DRI REGIONAL REVIEW FINDING

TO: Mayor John Park, City of Brookhaven
ATTN TO: Aronda Smith, Planning and Zoning Manager, City of Brookhaven
FROM: Mike Alexander, COO, Atlanta Regional Commission
RE: Development of Regional Impact (DRI) Review

Name of Proposal: Corporate Square Redevelopment DRI 4320

GSWCC NO. (LEVEL II) 00000XXXX
DRAWN BY EJD
DESIGNED BY MMM
REVIEWED BY DBA
DATE 01/31/2025
PROJECT NO. 017173008
TITLE
DRI SITE PLAN
SHEET NUMBER
C1-50

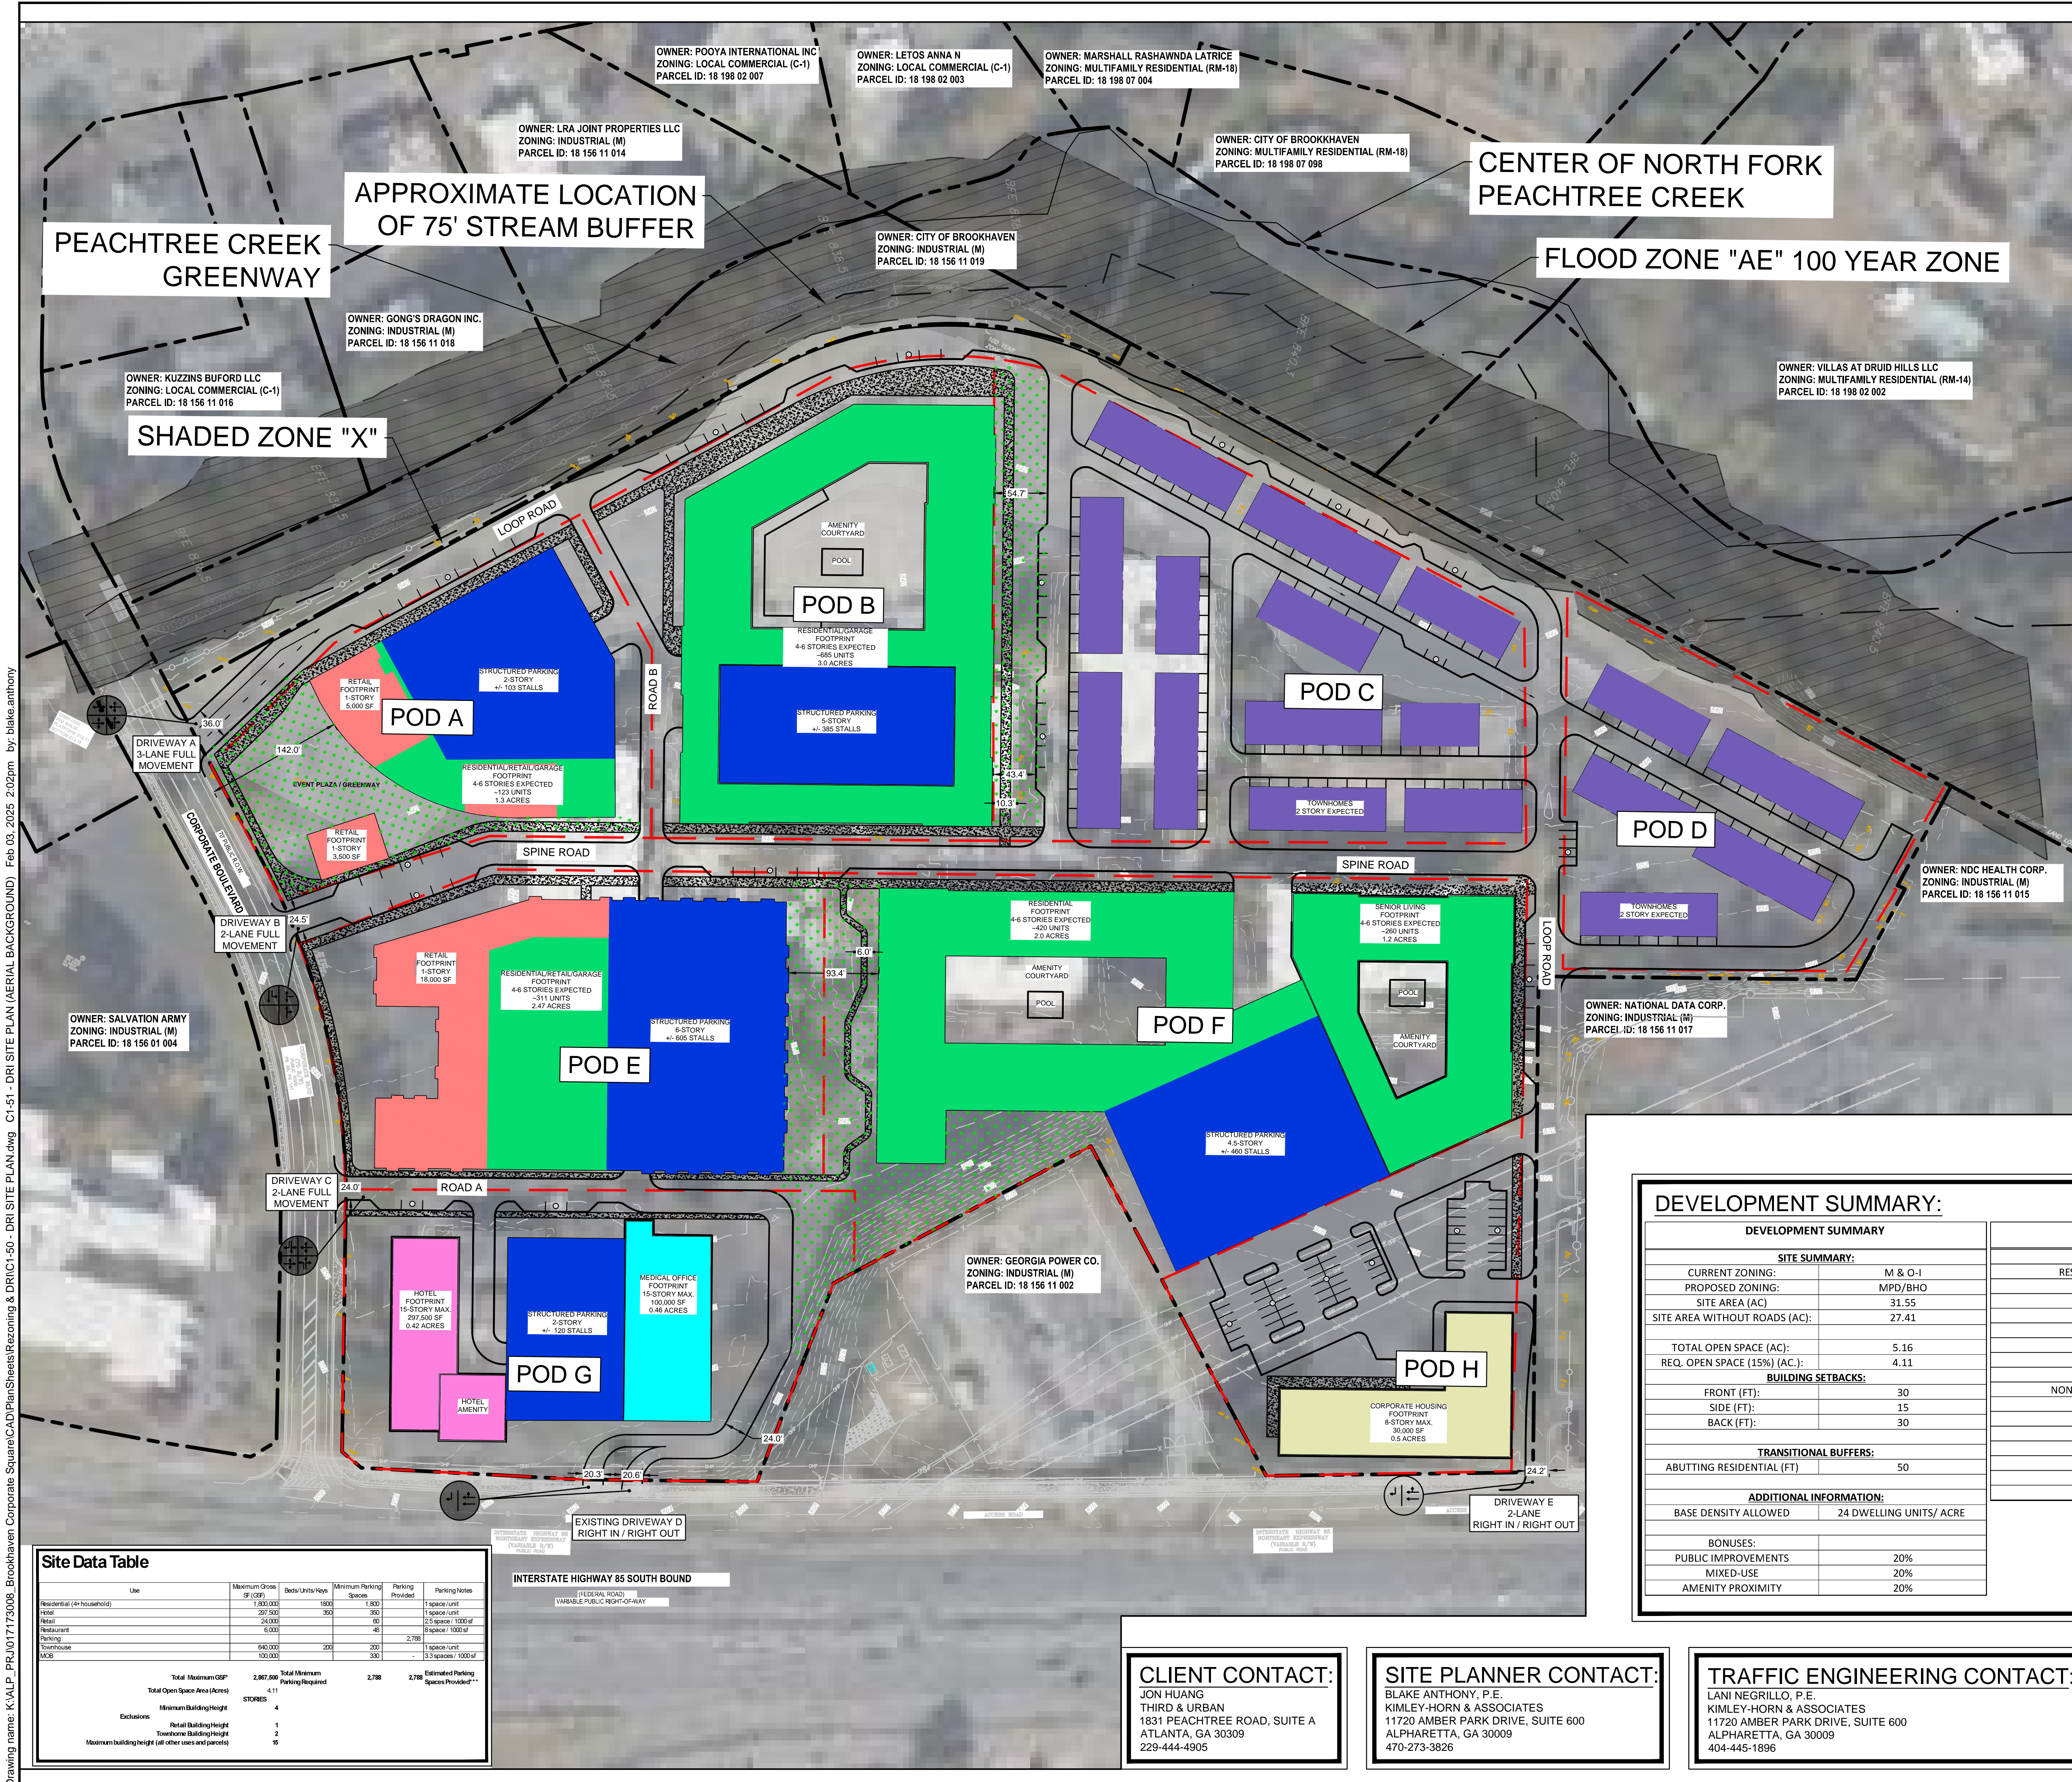
The project's connection to the adjacent Peachtree Creek Greenway is strongly supportive of regional multi-modal transportation policies. However, the proposed single connection point provides limited access to the Greenway. Ideally the main connection could be strengthened with a crosswalk and other features to extend the Greenway entrance into the site and a second connection point added within the site. Linking the proposed Greenway event plaza would directly to the Greenway would also offer a major

The sidewalk along the project's Corporate Square frontage appears to have some gaps and needs to be both continuous and of a generous width. Further, the 3 driveways in this frontage are not conducive to optimal pedestrian access and comfort. Ideally the driveways could be consolidated into two.

The project does not appear to include bicycle parking spaces and EV charging spaces; provision of adequate numbers of both would be supportive of regional multi-modal transportation policies.

The site plan shows portions of the development in Pods A, B, C and D within the Zone X floodplain area. Any altering or reconstruction of the loop road in Zone AE as well as development within Zone X will need to meet all applicable requirements under the City's floodplain and future floodplain ordinances.

The City of Brookhaven stream buffer protection ordinance – which establishes a 50-foot undisturbed buffer and additional 25-foot impervious surface setback – is governing rather than a 75-foot buffer required by unincorporated DeKalb County. Any portions of the project that extend into the applicable Brookhaven stream buffers would need to either meet the ordinance requirements or obtain variances from the City.

Floodplain The site plan shows small portions of FEMA Zone AE, or the 100-year floodplain, extending onto the existing loop road along the northern portion of the property. Based on the FEMA coverage for the project area, these may also include portions of the floodway. It also shows a floodplain area identified as FEMA’s Flood Zone X, which includes is the 500-year floodplain (0.2% annual flood chance hazard) as well as areas of 1% annual chance flood {100-year floodplain} with average depth less than one foot or with drainage areas of less than one square mile. The floodplain areas shown appear to be consistent with the current FEMA coverage of the project area. The site plan shows portions of the development in Pods A, B, C and D within the Zone X floodplain area. Any altering or reconstruction of the loop road in Zone AE as well as development within Zone X will need to meet all applicable requirements under the City’s floodplain and future floodplain ordinances.

Consider making the townhome garages alley-loaded rather than street-loaded. If street loading is used, make sure the driveways are deep enough to avoid vehicles hanging into the sidewalk and street. How does this tie into the greenway if there's a road between it and the greenway?

Consider expanding or programming the narrow greenspace between pods E and F to prevent it from being used as a pet relief area.

Move the hotel footprint closer to Corporate Boulevard to create an urban street edge.

Add sidewalk and crosswalks along the entire perimeter of the site, connected to sidewalk within the site to optimize pedestrian access to available bus stops;

At the intersection closest to northwest corner of the property, add an RRFB and median refuge to the crosswalk across Corporate Boulevard as well as ramps to ensure full ADA accessibility;

Add sidewalk connections so that Pod G and Pod H have direct pedestrian access to the frontage road sidewalk;

Add pedestrian access from the northern section of the site (north of Pod B) to Buford Highway to increase access to bus service along Buford;
